**SUBJECT:** Transmittal of Westinghouse Proprietary and Non-Proprietary Responses to U.S. Nuclear Regulatory Commission Requests for Additional Information Related to Structural Design for the AP1000 Application for Design Certification

# AP1000 DESIGN CERTIFICATION REVIEW

## Response to Request For Additional Information

Figure 3.8.3-1 (Sheet 1 of 7)

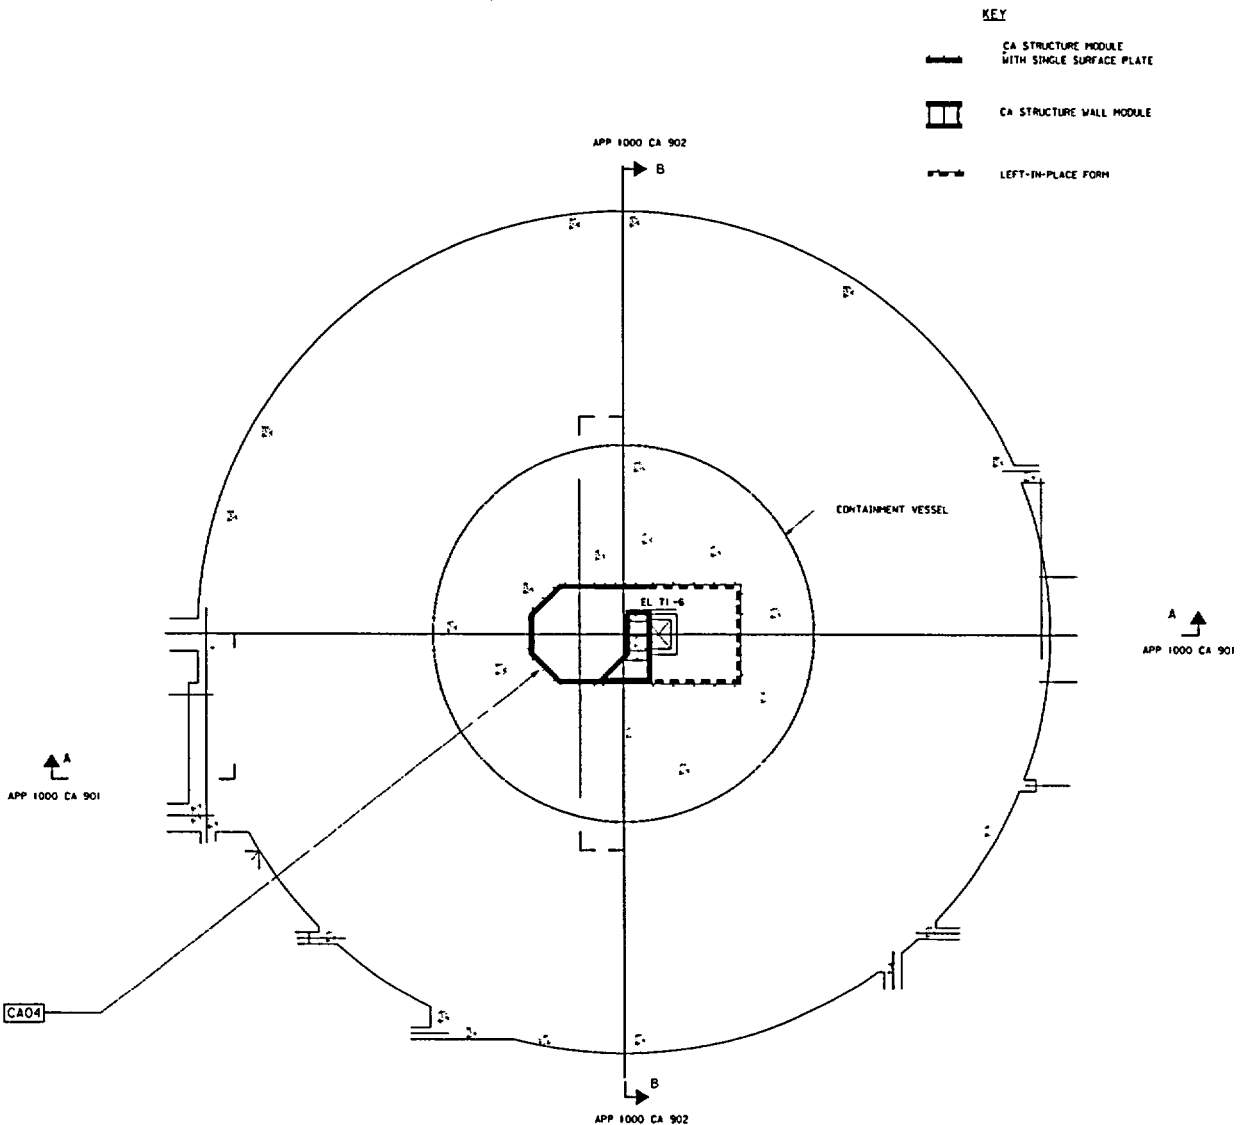
AP1000 DCD Figure 3.8.3-1 (sheets 1 through 7) refers to three types of wall modules: CA Structure Wall Module, Left-in-Place Form, and CA Structure Module With Single Surface Plate. Please provide the following information:

- A. A description, design approach, and analytical methods are provided for the first two types of modules; however, no descriptive information has been identified for the CA Structure Module With Single Surface Plate. A description for the CA type module similar to the information provided for the other two modules should be provided.
- B. On this figure, sheets 1, 2, 4, 6, and 7, there are solid heavy lines (without tick marks) for a structural module. However, this marking is not identified on the "Key." Please explain what is meant by the solid heavy line marking.

- B. On DCD Figure 3.8.3-1, sheets 1, 2, 4, 6, and 7, the solid heavy lines (without tick marks) are the two faces of the CA structural wall module. The heavy lines are joined by a representation of the trusses and are identified on the "Key." This representation is missing on some sheets and is being added.

**Revise Figure 3.8.3-1 as shown in attached figures.**
